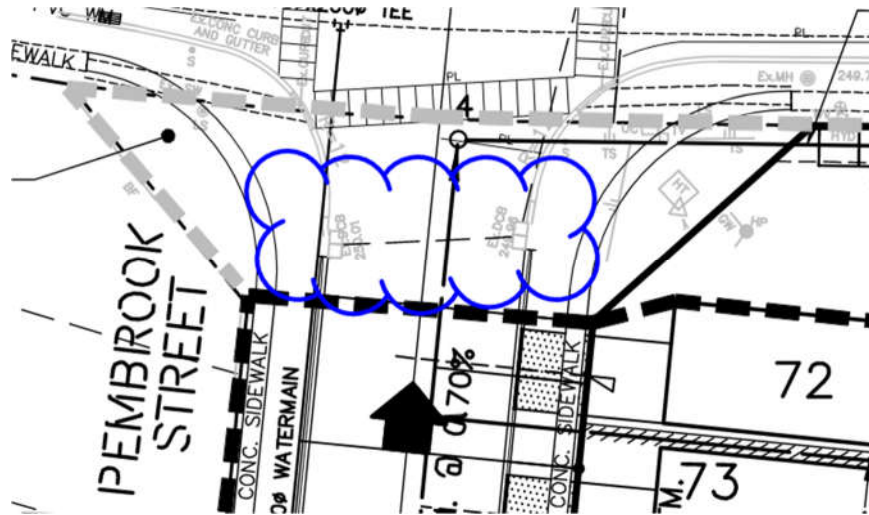
1. As discussed previously, please clarify if a pair of ex. DCBs on Pembroke St. will remain connected to the Queensgate storm sewer. The engineering plans show no CBs on Pembroke St., therefore under the proposed condition, road runoff from Pembroke St. and drainage from lots fronting Pembroke St. will be captured by the ex. DCBs near the Queensgate intersection. This does not match the storm drainage plan. Please add a pair of CBs that can sufficiently capture a minor system flow between the highpoint on Pembroke St. (in front of Lot 82) and the ex. DCBs.

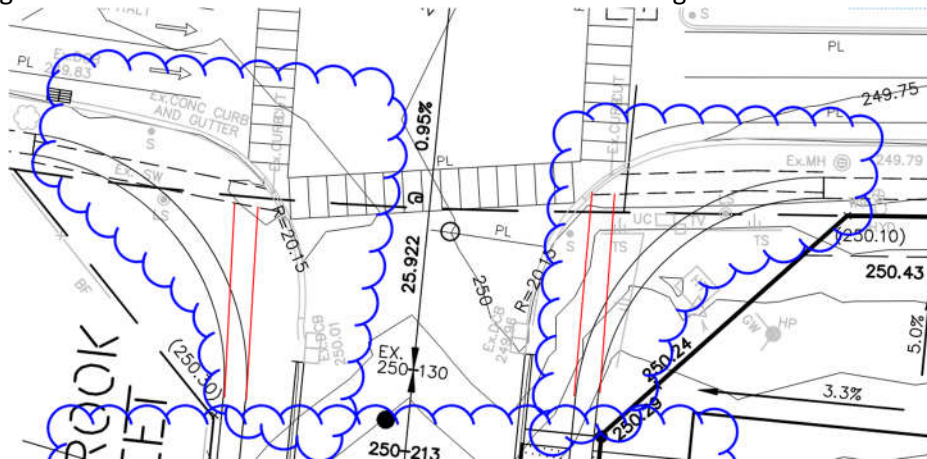
2. Since the existing ditch will be removed, instead of draining towards Queensgate Boulevard, the drainage from the existing lots on Richelieu Court will drain to the proposed storm sewer on Pembroke Street. The storm drainage plan should be revised to reflect this change and the storm design chart should include the external drainage in the chart.
3. The existing drainage area ($A=0.08$ Ha) shown on the storm drainage plan is not clearly defined. Also, the uncontrolled drainage area (highlighted in red below) on Lots 71 and 72 must be identified on the plan and adequate justification must be provided.

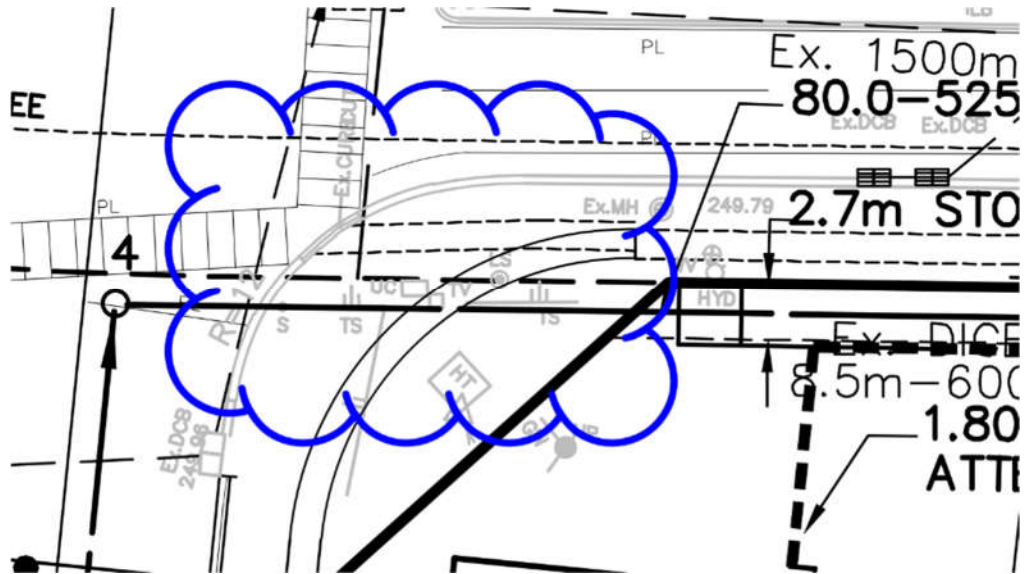
4. The sidewalks on Pembroke Street should perpendicularly connect to the ex. sidewalks on Queensgate Boulevard at the intersection. Please see below diagram.
